Addendum No. 6

South Dade Regional Library Interior Renovations

ADDENDUM NO. 6
24-JAN-2025

RFI QUESTIONS AND RESPONSES CONTINUED:

Q107. Electrical Plan (E-6) It is requested to add two new 3p, 25A circuit breakers to the A/C panel, please see the image below:

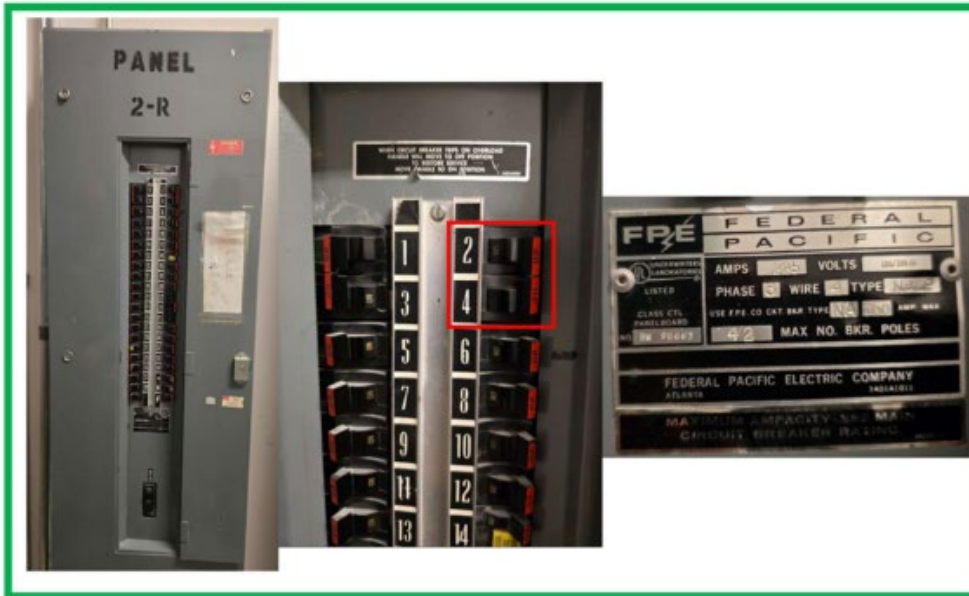
The panel manufacturer is Federal Pacific as shown in the image below: This manufacturer is no longer on the market, so these two circuit breakers cannot be obtained on the market. Please advise
Response Q107: If parts are not available the panel should be replaced.

In Reference to item j.

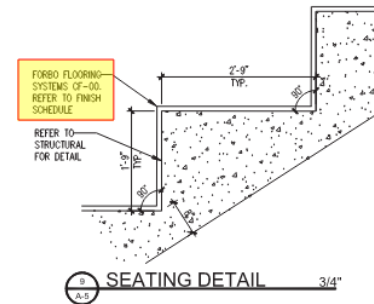
- i. VCT was specified for IT rooms. Please confirm SDT won't be required at those areas. **Response Q113i: Refer to response Q95.**
- j. 106 Aisle Stair seating was specified on A-11 with 4 Vinyl. However, details on A-5 call for Forbo flooring there. Please clarify finish required at that location. **Response Q113j: Refer to response Q96.**

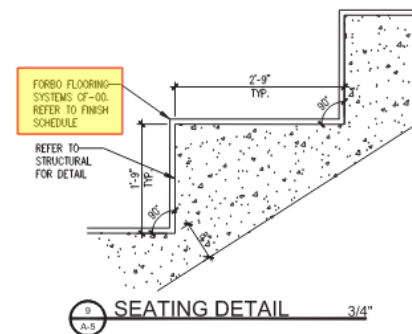
- m) 106 Aisle Stair seating was specified on A-11 with 4 Vinyl. However, details on A-5 call for Forbo flooring there. Please clarify finish required at that location. **Response Q114m: Refer to response Q96.**
